Newmarket Road Corridor

This document describes the proposals of the Cambridge Cycling Campaign for improvements to cycle routes along the Newmarket Road corridor.

Document No. N9801
March 1998

Left: Approaching Ditton Lane. Hard to get into the central cycle lane

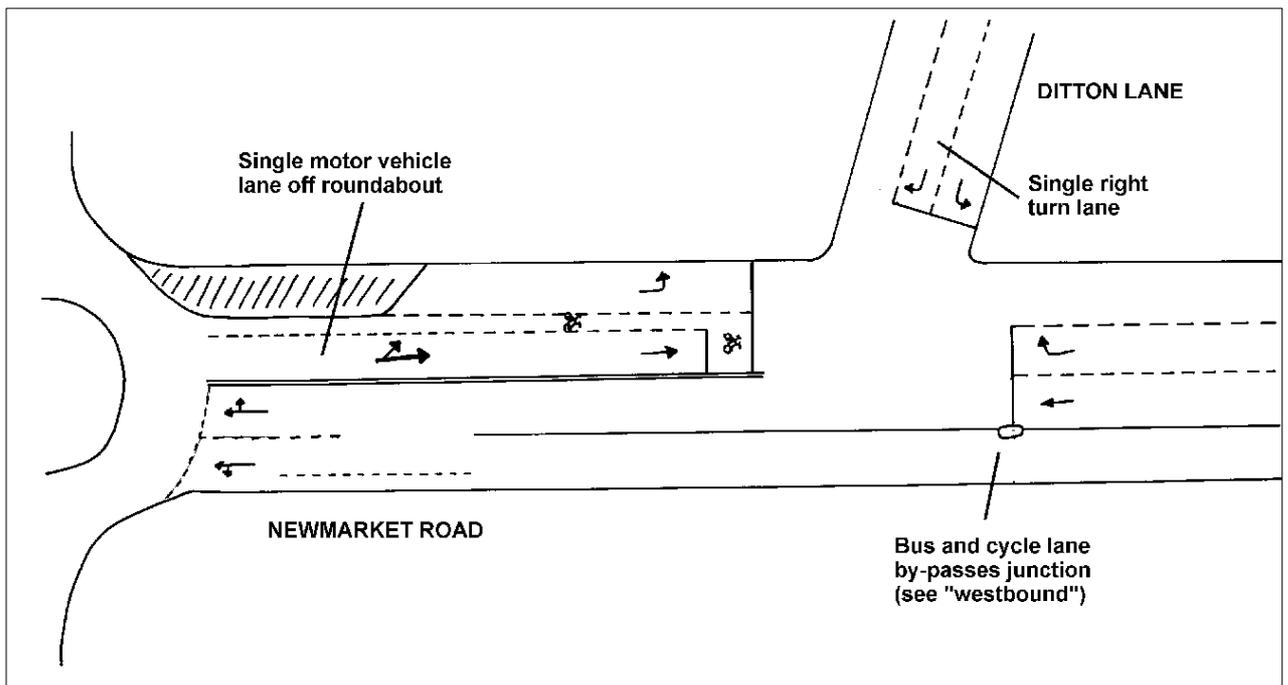
This short stretch is probably the scariest section in the whole length of Newmarket Road.

There is a left-turn-only lane for vehicles turning left into Ditton Lane. Because of this, cyclists intending to go straight on have to position themselves between two streams of fast-moving traffic. The red advisory cycle lane provided between the two traffic lanes helps a lot here, but the experience is still highly unpleasant: the worst part is actually getting into the cycle lane in the first place.

Major changes in road layout are required here. The simplest solution would be to reduce the number of lanes leaving the roundabout from two to one. Then, the left-turn lane could be marked as being a definite left turn off this lane, much closer to the junction, in the manner established elsewhere in the city such as the left-turn from East Road to Mill Road.

The red surface on the existing advisory lane is in poor condition and needs completely replacing.

We would like to see a forward stop line at the end of the straight-on traffic lane. It would allow waiting cyclists to position themselves in a much safer position than they can at present.

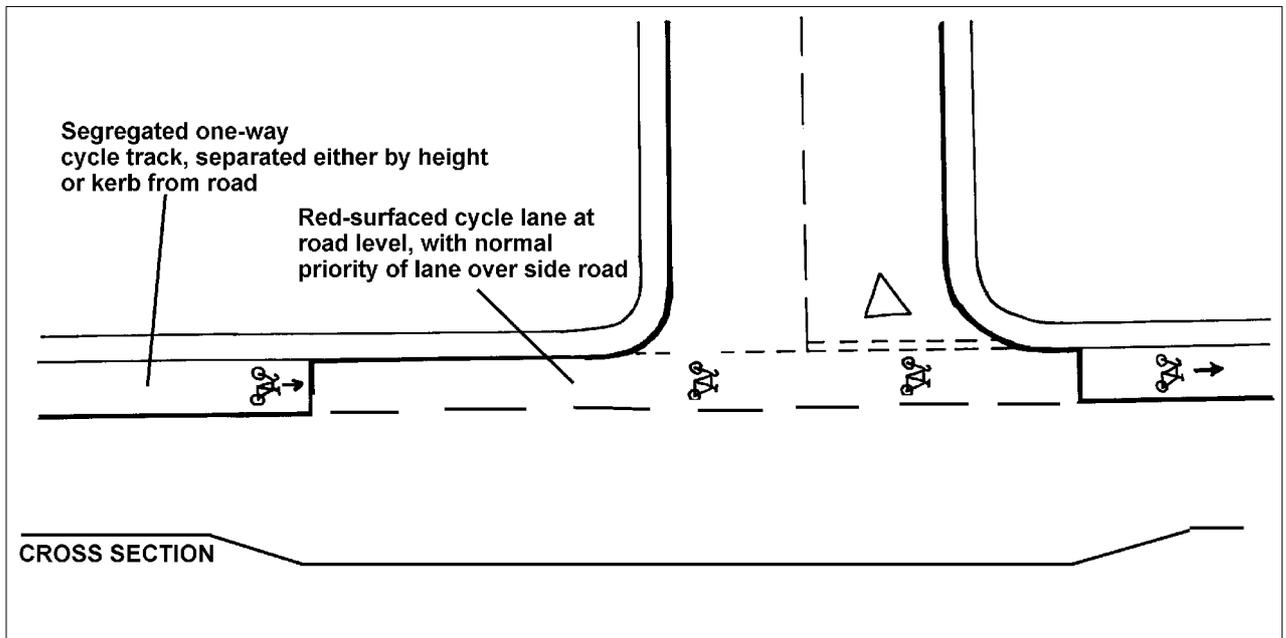
We would like to see a high-quality, 2m wide, one-way cycle track constructed between here and the Park and Ride site.

The cycle track should have priority over side roads. This should be reinforced by continuing the cycle track across such side roads on a raised level.

We are aware that there is reluctance to give priority to off-road cycle tracks, so if this is not possible then instead of crossing the side road on a raised level, the cycle track should 'turn into' a cycle lane (with priority) across the side roads.

The following diagram shows the type of arrangement we have in mind:
